**King's Mark
Environmental
Review
Team
Report**

**MEETING HOUSE HILL
SCHOOL BALLFIELDS
NEW FAIRFIELD,
CONNECTICUT**

Environmental Review Team Report

MARCH 1988

PROPOSED PLAN

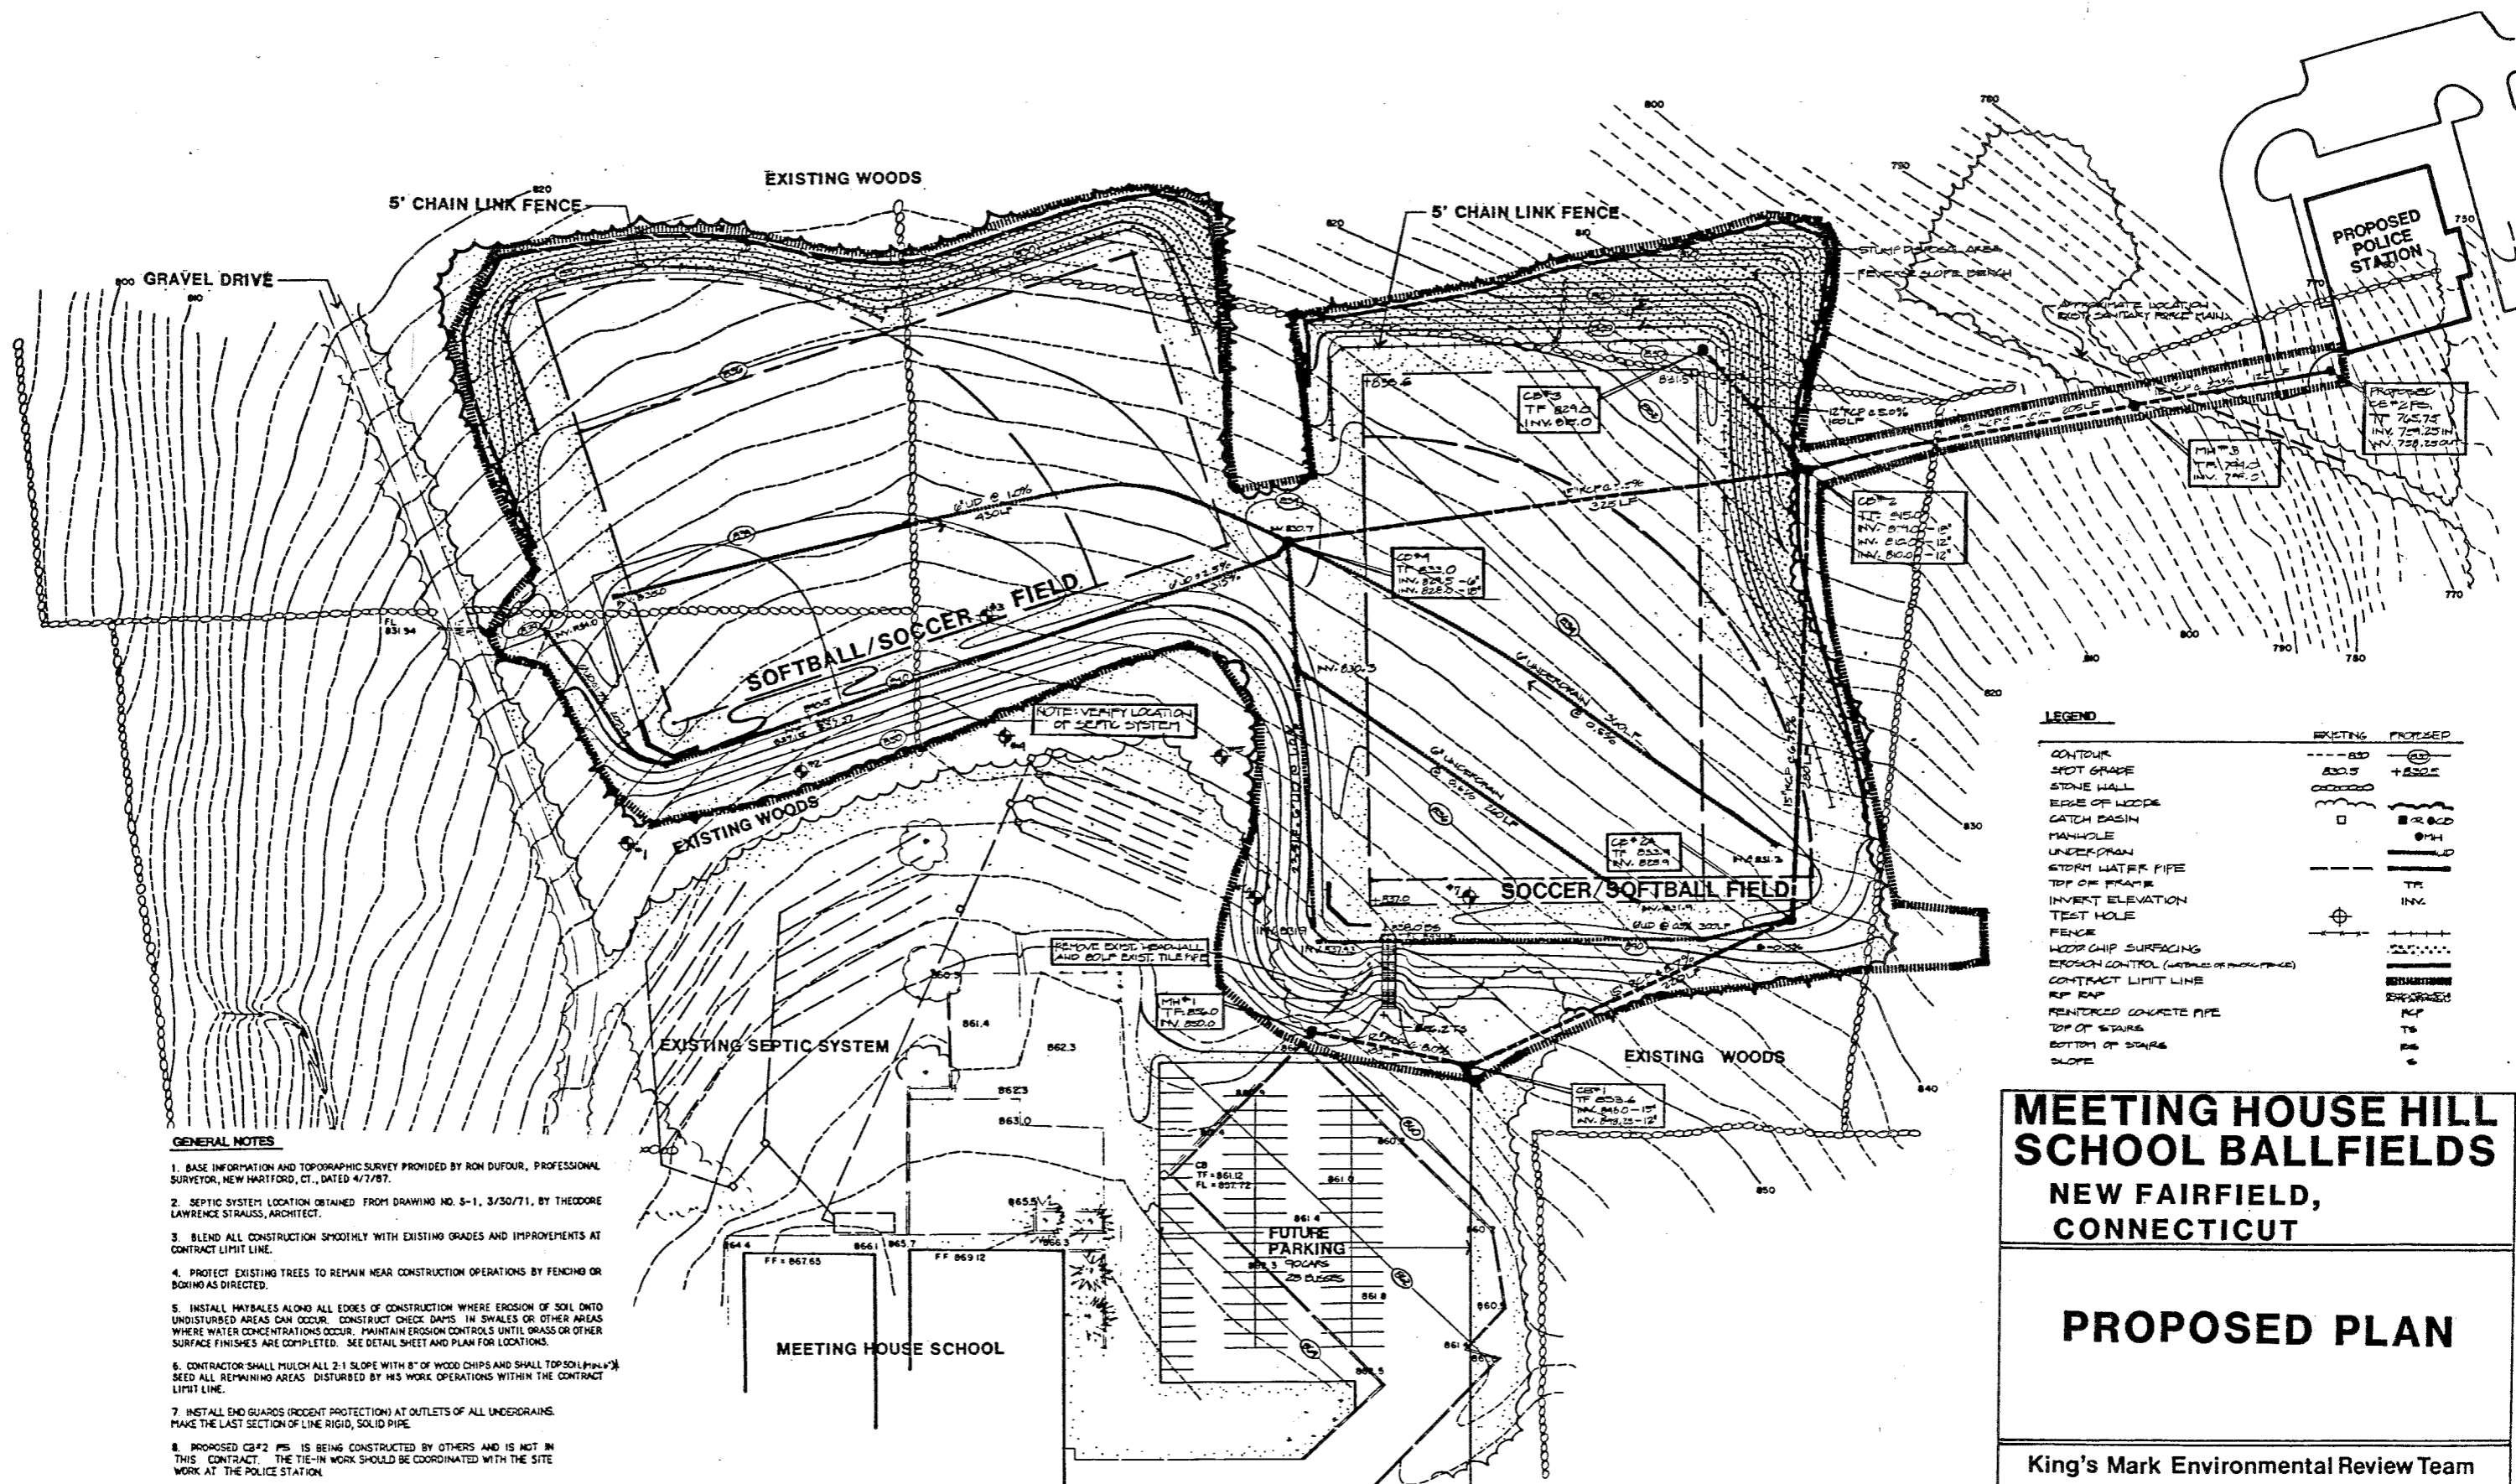
6 feet to 11.5 feet below ground surface (see Figure 2). It would be wise to conduct a few borings in the ballfield area to determine if the bedrock surface will be encountered during field construction. If the bedrock surface was encountered during the construction of ballfields, blasting would probably be required. Blasting activity can be difficult, especially in developed areas, and very costly.

As mentioned earlier, there is a need for drainage in order to keep the proposed fields dry. The project designer has proposed the installation of underdrains along the cut area (south side of field) and throughout the field area. If properly installed these drains should effectively intercept surface

The installation of the proposed underdrain and drainage pipes in the ballfields and the proposed cut along the south side raises two potential concerns that the Town needs to consider. First, the installation of surface and groundwater drains for the ballfields will preclude the future use of the approximately 7 acre area for expansion of the septic system for Meeting House Hill School. It is understood that the existing septic system is presently failing and efforts are being made to renovate and expand the system. Public sewers are not available to this area. The area of proposed expansion appears to be between test holes 4 and 5 on the site plans distributed to Team members on the review day. If the need for septic system renovation arose, suitable areas for such expansion would be severely restricted by the drainage systems in the proposed fields, parking lot area and the on-site well serving the school. The only potential expansion area appears to be the land west of the gravel road behind the school. In this regard, school officials should probably discuss possible areas for future expansion with the Town Sanitarian before the ballfields are constructed. It might also be wise to conduct soil testing to determine subsurface conditions in the area. Without public sewers in the areas and extremely limited area for septic system expansion, the Town could be left in a very difficult position.

Second, the location and close proximity of the existing septic system serving the school to the proposed cut area and underdrains system warrants close attention. Every effort should be made to ensure that untreated waste does not break out along the north facing slope (cut area) down gradient from the existing septic system, and that it is not intercepted by the proposed drainage system. Both scenarios could result in a public health hazard condition as well as contaminate surface waters in the area. It seems likely that the existing septic system closest to holes 4 and 5 would need to be relocated, if the ballfields are constructed. Also, the area currently proposed for new leaching field expansion should be abandoned and relocated elsewhere, since it would be located at or near the proposed cut area. Finally, although the public health code requires a minimum separating distance of 50 feet when the drain is located down gradient from the septic system, it might be wise to conduct hydraulic analysis of the soil in the area to determine if greater distances should be required.

Controlling these hazards requires detailed planning prior to a construction start to prepare the site for a trouble-free activity. More intensive planning is needed for the artificial drainage system to insure the utility of the completed project. The artificial drainage system is absolutely essential when major regrading is planned with a resulting composite area consisting of raw hardpan and compacted hardpan fill. Recreation fields in particular demand a total system of subsurface drains, generally installed at forty foot intervals throughout the entire playing surface, to assure full season use. The grading plan for this proposal does not show an adequate drainage system in the completed fields.

**CUT SLOPE
ENVELOPE DETAIL**

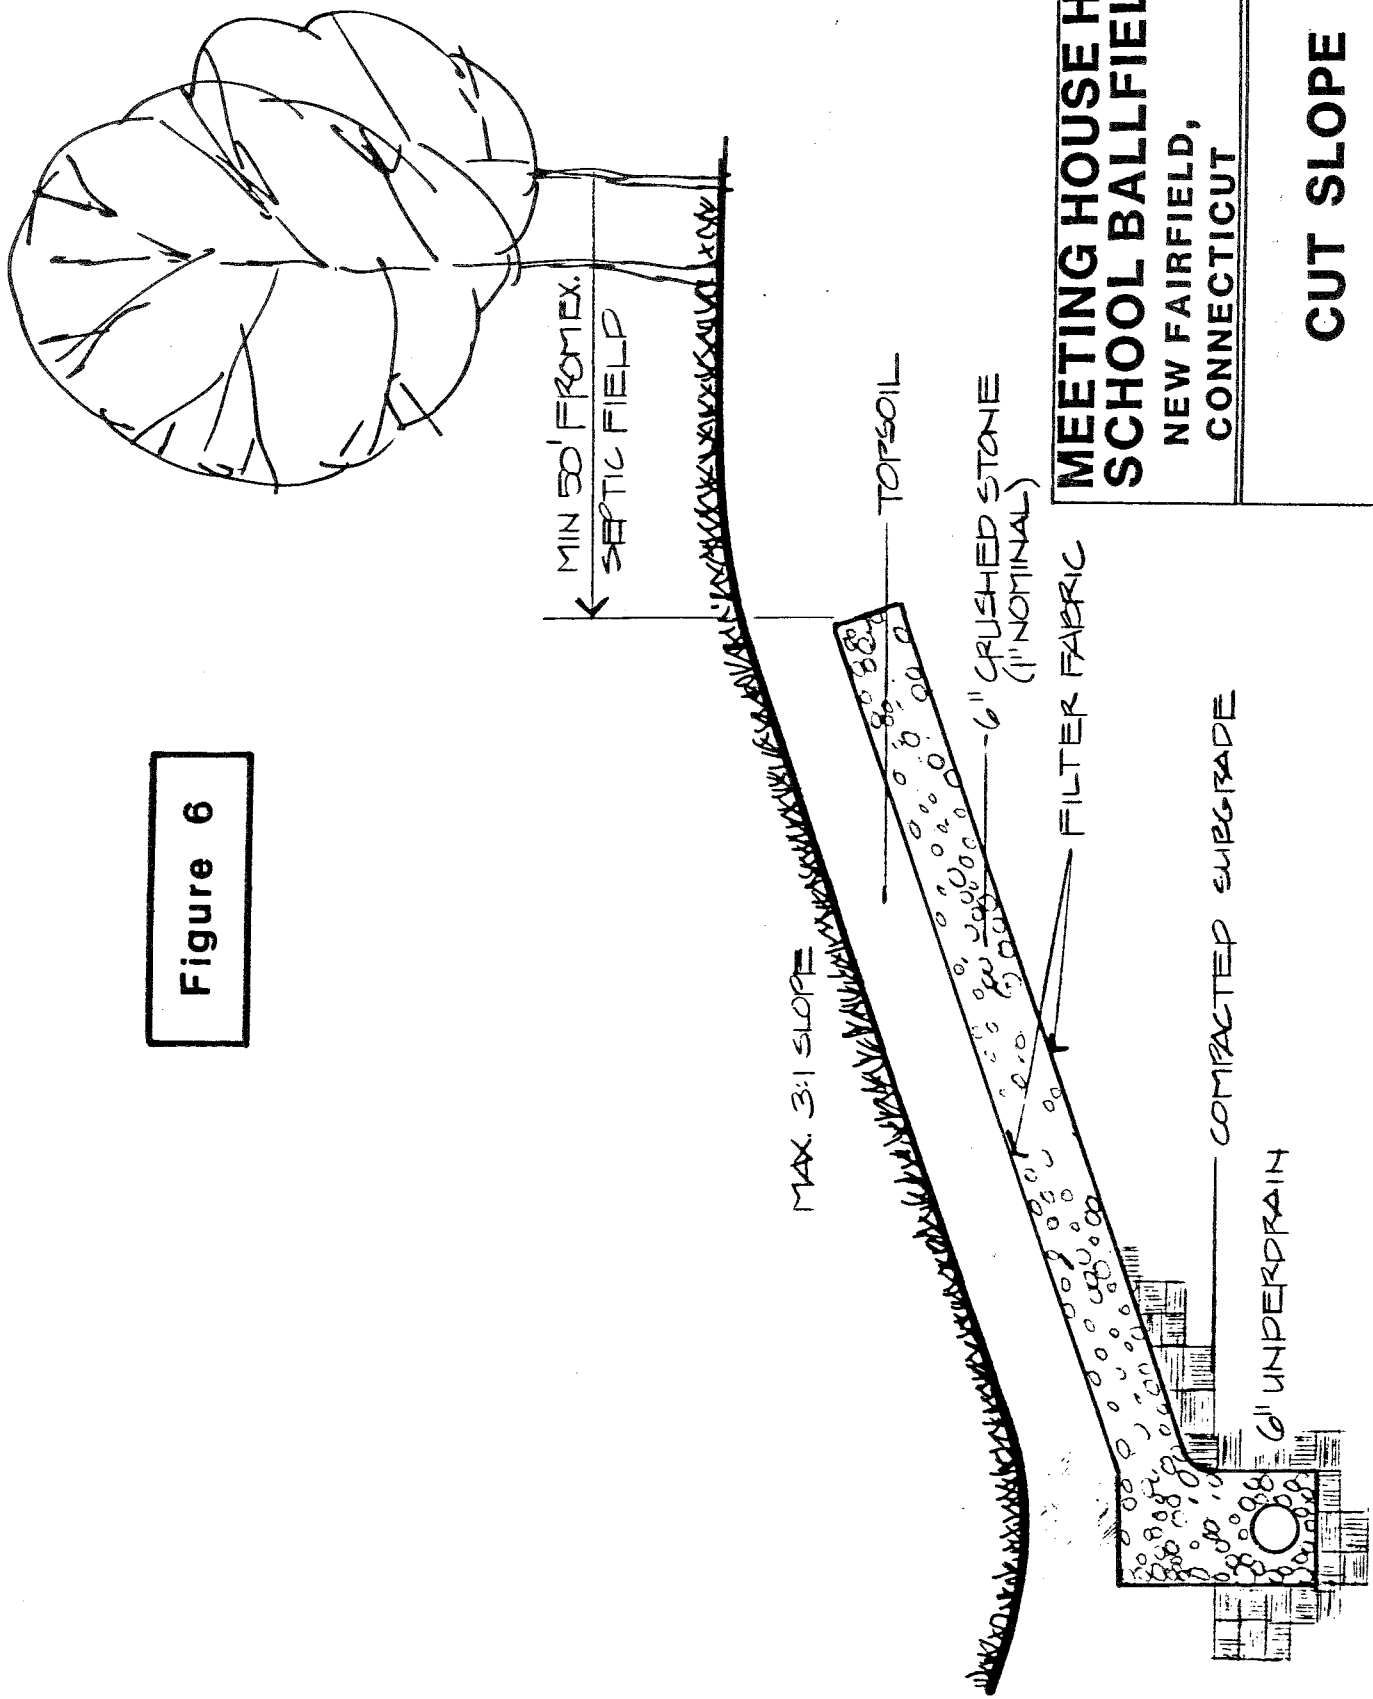
The stone-filled envelope slope drainage proposal for cut slopes will protect these slopes from falling (see Figure 6). It must, however, be installed at the correct depth to intercept the subsurface flow line. This depth may vary across the slope; accuracy in placement is crucial. It is unavoidable that effluent from the existing leaching field will be picked up in a portion of the slope drain. Should the additional leaching field be installed as planned, a serious incompatibility would exist.
